CITY OF LOS ANGELES
INTER-DEPARTMENTAL CORRESPONDENCE

3800 S. Vermont Av
DOT Case No. CEN 16-44979

Subject: **TRANSPORTATION ANALYSIS FOR THE PROPOSED LUCAS MUSEUM
OF NARRATIVE ART LOCATED AT 3800 SOUTH VERMONT AVENUE**

TABLE 12
FUTURE WITH PROJECT CONDITIONS (YEAR 2021)
INTERSECTION LEVELS OF SERVICE AND SIGNIFICANT IMPACTS

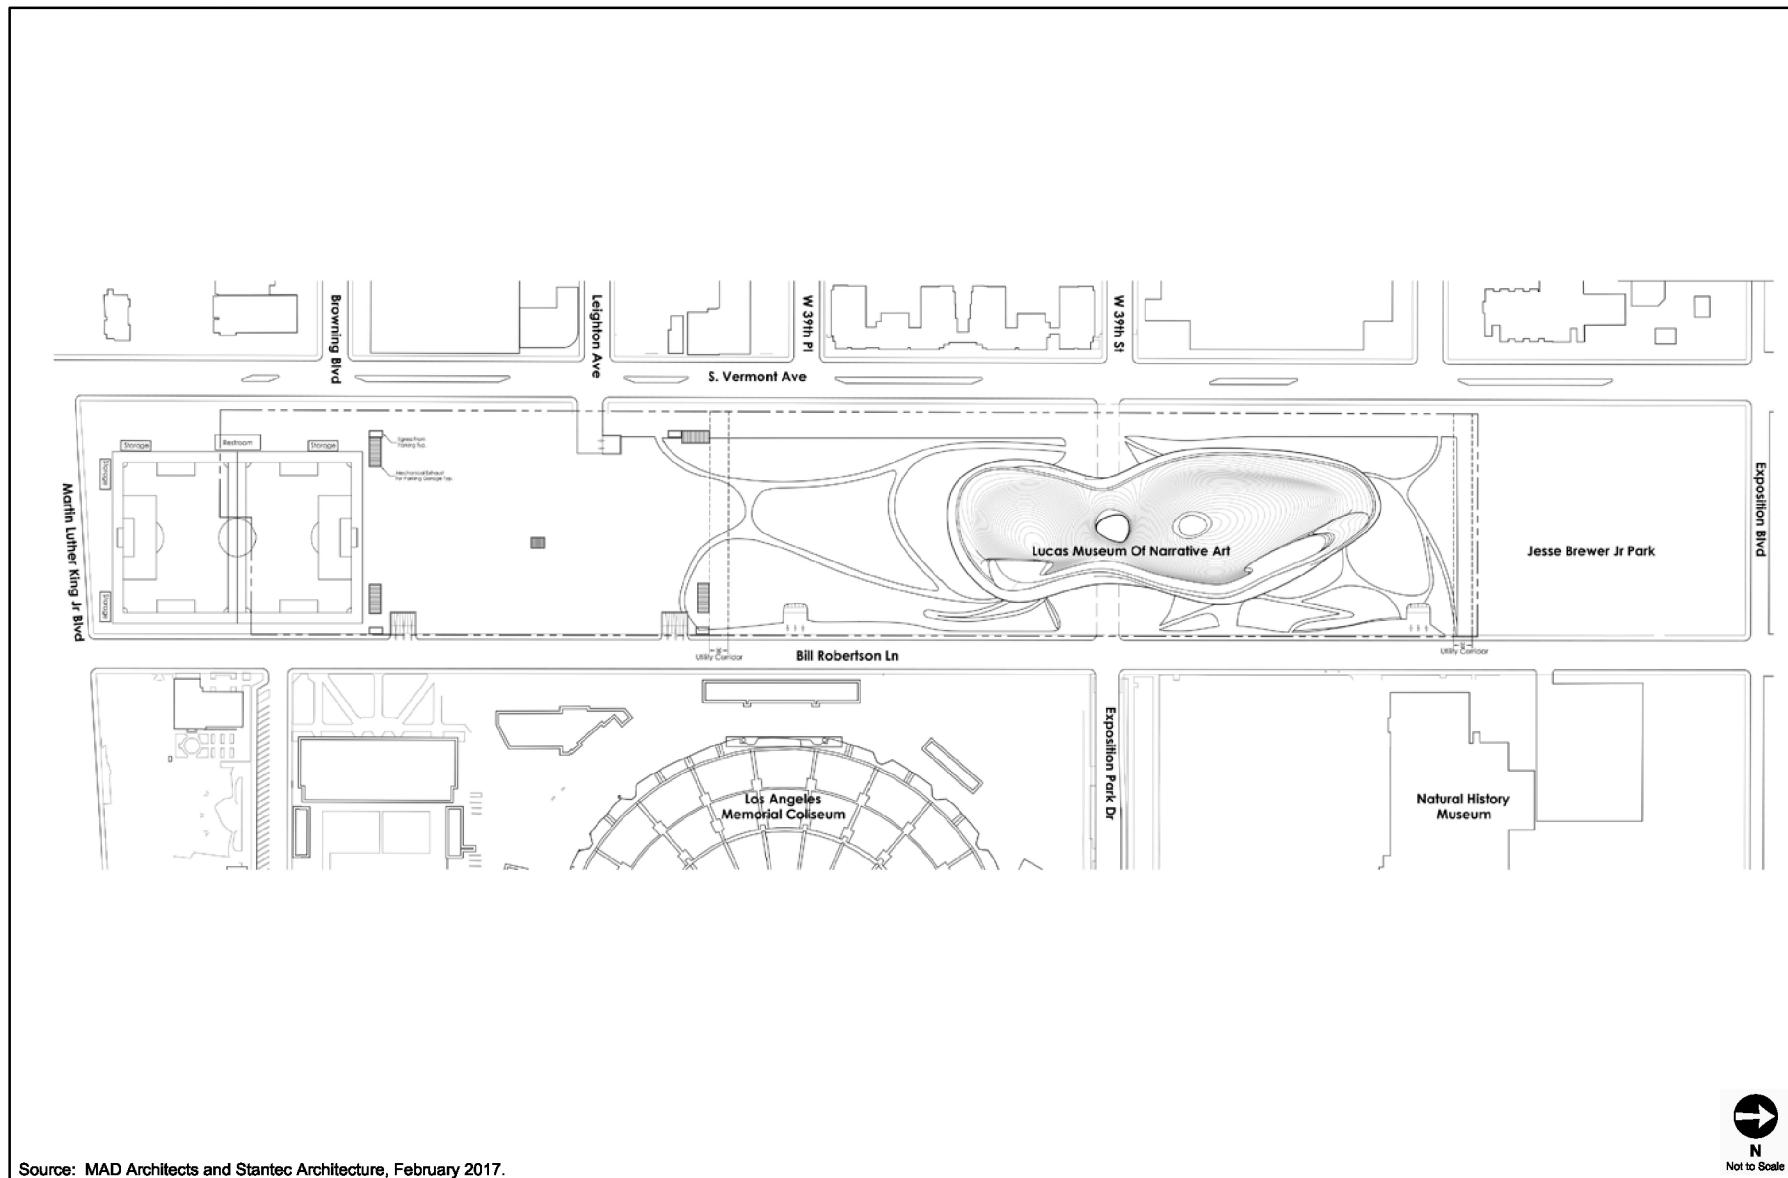
The Department of Transportation (DOT) has reviewed the transportation study prepared by Gibson Transportation Consulting, dated March 2017, for the proposed Lucas Museum of Narrative Art located at 3800 South Vermont Avenue. In order to evaluate the effects of the project's traffic on the available transportation infrastructure, the significance of the project's traffic impacts is measured in terms of change to the volume-to-capacity (V/C) ratio between the "future no project" and the "future with project" scenarios. This change in the V/C ratio is compared to established threshold standards to assess the project-related traffic impacts. Based on DOT's traffic impact criteria¹, the traffic study included the analysis of twenty intersections and determined that none of the study intersections would be significantly impacted by project-related traffic. The analysis supports an addendum to the 2003 Draft Environmental Impact Report for the Los Angeles Memorial Coliseum Renovation Project. The results of the traffic impact analysis, which adequately evaluate the project's traffic impacts on the surrounding community, are summarized in **Attachment 1**.
